# 2022 S4.55(1a) BCA Assessment Report

Aspect Industrial Estate – Warehouse 2  
Lots 54-58 Mamre Road, Kemps Creek

Mirvac

Reference: 220480

Figure 1 – Warehouse 2 Perimeter Vehicular Access per BCA C3D5.

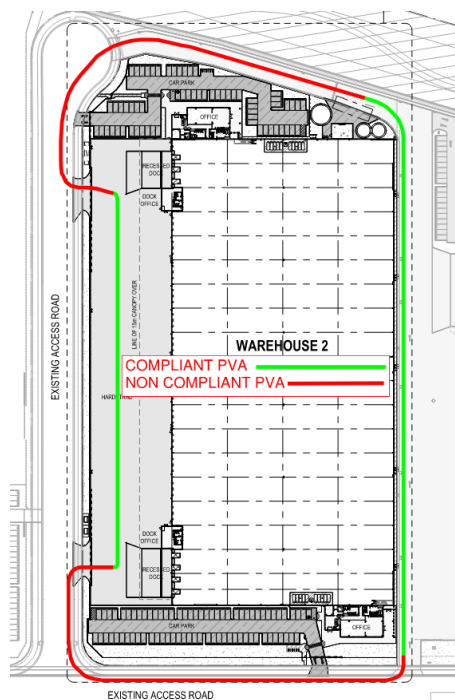
**Comment:** The proposed building does not comply with the provisions of C3D5 and thus the following non-compliance issues are required to be addressed as a Performance Solution by the Fire Engineer to demonstrate compliance with Performance Requirement C1P9:

- + Perimeter Vehicular Access is greater than 18m around the northern and southern external walls of the warehouse.

Note 1: Any proposed gates are to achieve no less than 6m unobstructed width or the reduced width will need to be included in the above Performance Solution.

Note 2: The driveways providing vehicular perimeter access must be designed with adequate loading capacities to withstand a fire truck and the gradients of any ramps and swept paths should take into consideration the requirements of the FRNSW Fire Safety Guideline – Access for Fire Brigade Vehicles and Firefighters.

Note 3: It is noted that restriction of use or s88b instrument for the western hardstand is to be implemented prior to the subdivision of warehouse 2 or 3.
